**HISTORIC PRESERVATION REVIEW BOARD  
STAFF REPORT AND RECOMMENDATION**

Property Address:	<b>1742 Church Street, NW</b>	<b>X</b>	Agenda
Landmark/District:	<b>Dupont Circle Historic District</b>		Consent Calendar
Meeting Date:	<b>May 3, 2012</b>	<b>X</b>	Concept Review
H.P.A. Number:	<b>12-280</b>	<b>X</b>	Alteration
Staff Reviewer:	<b>Jonathan Mellon</b>		New Construction
			Demolition

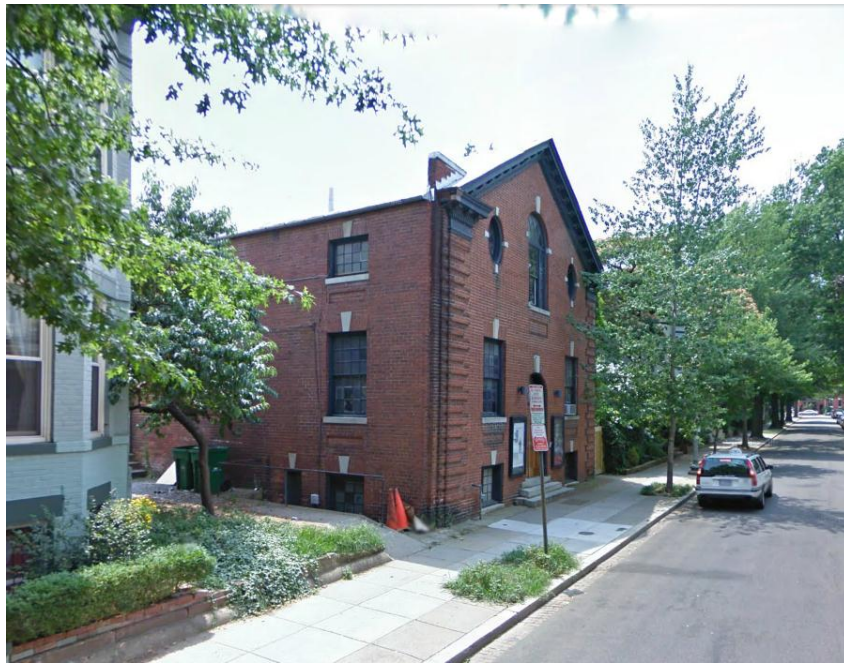
While the proposed addition would be subordinate to the existing building, consistent in size with other additions approved by the Board, and clearly differentiated due to its contemporary design, several aspects of the proposal would benefit from further study.

As proposed, the existing main entrance would no longer be functional; as such, the historic relationship of the building to the street would be altered. While mindful of the need to provide for ADA accessibility and improved functionality, the question of what should be done with the historic main entrance is an open one. While leaving the entrance unaltered (as is proposed) is an acceptable choice, repurposing this opening should be considered as an opportunity to activate the space and help it engage with the street. A possible option would be to replace the doors with a window that would allow for a visual connection between the exterior and interior spaces, or alternatively to use the space for the location of the light boxes that presently flank the doors which would serve to advertise theatre productions.

Also worthy of further study is the addition's setback and size. While the impact of the addition on the side (east) elevation is somewhat mitigated by being set back from the primary façade, it would largely obscure the articulated side (east) elevation and result in the loss of historic fabric, most notably the window. Part of the building's prominence on the street is that it projects to the edge of the public sidewalk, approximately eight feet further than the rowhouses on the block. The addition's setback is not sufficient in retaining that prominence. A larger setback, aligned with or behind the front façade of the adjacent rowhouse, would result in the addition being more subordinate to its historic neighbor while at the same time serving to preserve the view of the side (east) elevation of the theatre.

As designed, the single entrance door and stair landing are extremely small for a public assembly building. While mindful of the applicants desire to avoid a BZA hearing (the proposed +/- 150SF addition is all that can be accommodated under the current zoning), the applicants should consider expanding the addition's size to allow for greater ease of entry and exit. As the new primary entrance, the new door should also be prominent and clearly legible from the street.

The design of the addition could be simplified by removing the proposed undulating colored/opaque glass panels while leaving in place the panel for the signage. Having a more transparent addition would allow it serve as a transitional space between the exterior and historic building; this could also be furthered by preserving as much of the side (east) elevation as possible – the cut outs for the new stairs and elevator should be kept to a minimum.

The HPO recommends that the Review Board find the general concept for a side addition to be compatible with the character of the historic district, but to encourage the applicants to restudy the treatment of the building's existing front door and the design, size and setback of the addition.
